TVFRC Building Committee meeting

October 15, 2026 6:30 pm

PROJECT:
Trumbull Veterans Ctr Ph2
1 Veterans Circle
Trumbull, Connecticut 06611

Prime Contract Potential Change Order #009: Generator Feeders & Startup

Ground Floor Plan

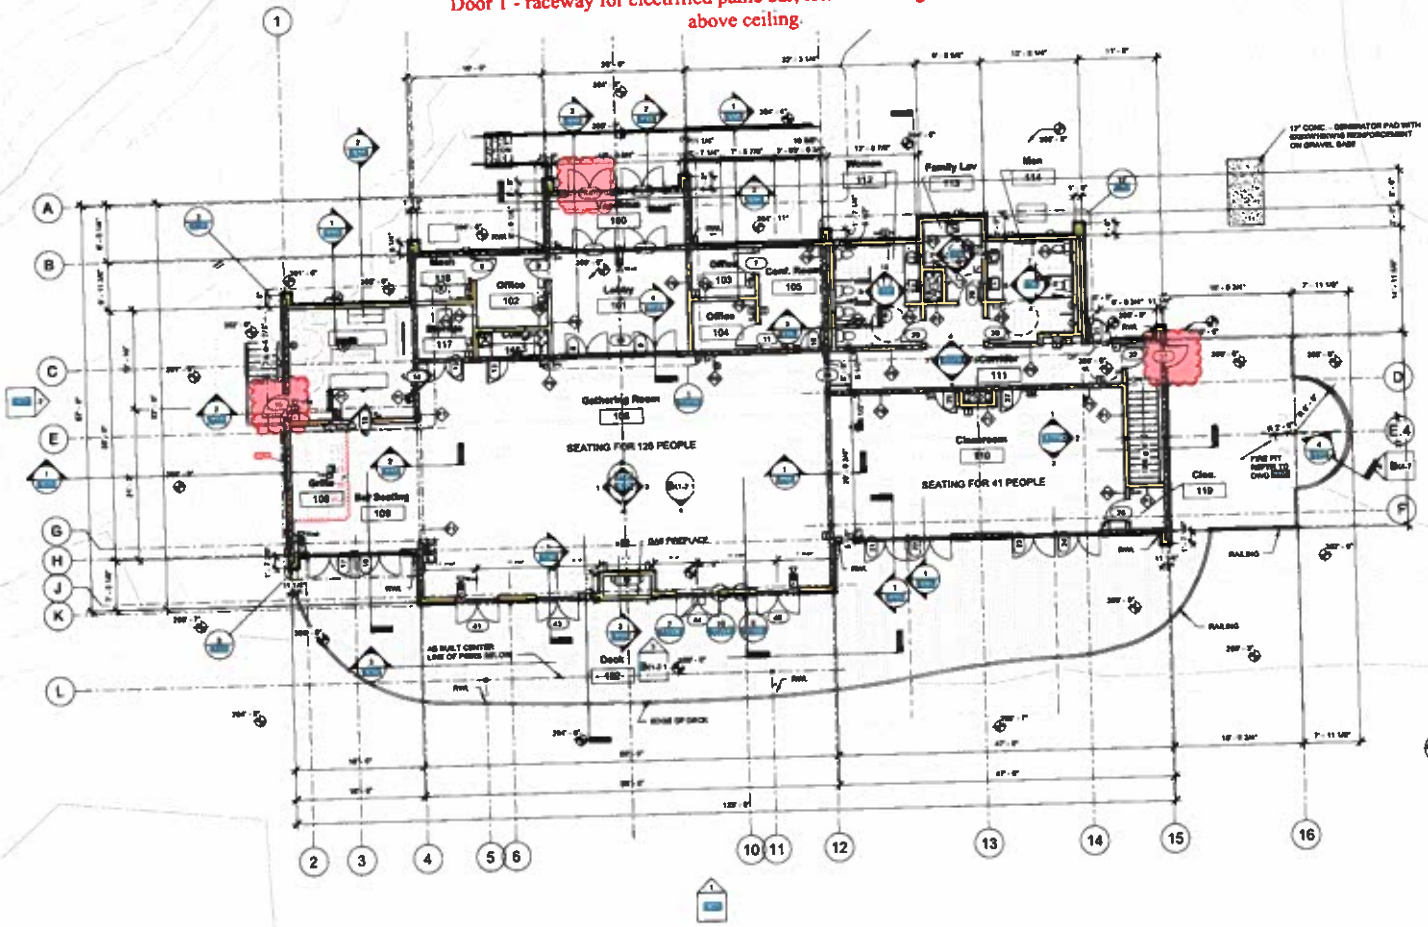
- All keyed locks would be changed to Schlage ND series.
- Cylinder housings would be updated to match the Town's Schlage permanent cores.
- Openings 16 & 37 would add electric strikes field-cut into the HM frames.
- Opening 1 would be retrofit to add a latch retraction kit to the scheduled panic hardware.

Add infrastructure & pull strings for card readers at these locations.
Security cabling and devices by others.
Doors 16 & 37 - raceways to j-box above ceiling to strike side.
Door 1 - raceway for electrified panic bar, left leaf. Bring to Office 102 above ceiling.
